# NEWMAR CORPORATION WARRANTY DEPARTMENT

## RECALL SERVICE BULLETIN

DATE ISSUED	MODEL YEAR(S) AFFECTED	RSB #
12/08/2016	2017	471
<b>BRAND</b>		
Bay Star Sport <input type="checkbox"/>	Ventana <input type="checkbox"/>	Essex <input checked="" type="checkbox"/>
Bay Star <input type="checkbox"/>	Dutch Star <input type="checkbox"/>	King Aire <input checked="" type="checkbox"/>
Canyon Star <input type="checkbox"/>	Mountain Aire <input type="checkbox"/>	Other <input type="checkbox"/>
Ventana LE <input type="checkbox"/>	London Aire <input checked="" type="checkbox"/>	
<b>DESCRIPTION</b>		
<p>Newmar Corporation has decided that a defect relating to motor vehicle safety exists in specific motorhomes. NHTSA # 16v 768 TC # 2016-524</p> <p><b>Issue:</b> On certain motorhomes, the HWH hydraulic entry step controller is not functioning as designed and may allow the step to retract unexpectedly in some circumstances with the entry door open. If the step controller is not operating as intended, it may increase the risk of an accident and/or injury.</p> <p><b>Correction:</b> Authorized Newmar service facilities will inspect the step and correct the controller with a software update when necessary.

### Preparing for the Software Update

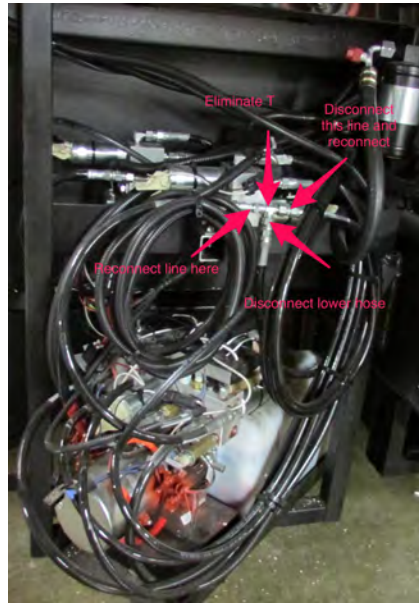
1. Make sure both house and chassis power is being supplied to the coach, and place the key ignition in the run position.
2. Locate the circuit board and power connectors in the upper corner of the first storage bay on the passenger side of the coach.
3. Unplug the two large connectors (one is black and one is tan), along with the smaller grey connector.

4. Plug the Step Module Programmer into the larger black connector to reset the system. Note: Use the 110 volt outlet in the bay compartment to supply power to the programmer.
5. Once the led indicates success the update is complete, plug in all of the connectors in their original locations.

## Correcting the Hydraulic Plumbing Lines at the Rear Manifold

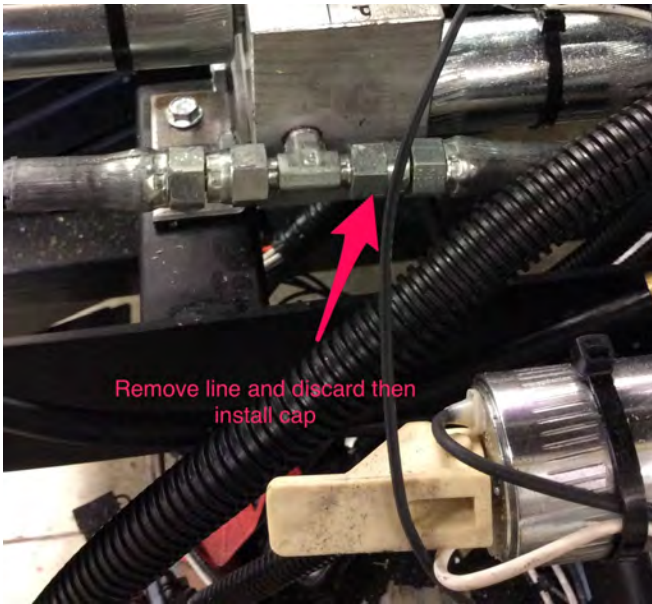
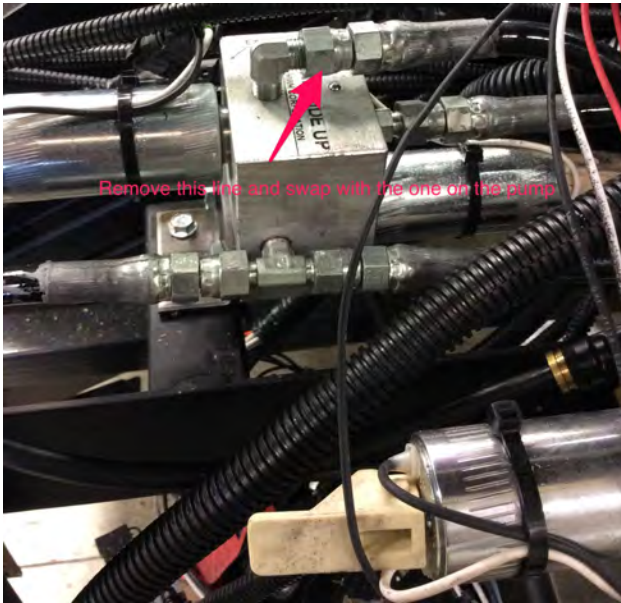
12. From the rear manifold, disconnect the loose hose, and install a cap.
13. Discard the removed hose.

14. From the top of the rear manifold, remove the hose from the elbow connection.
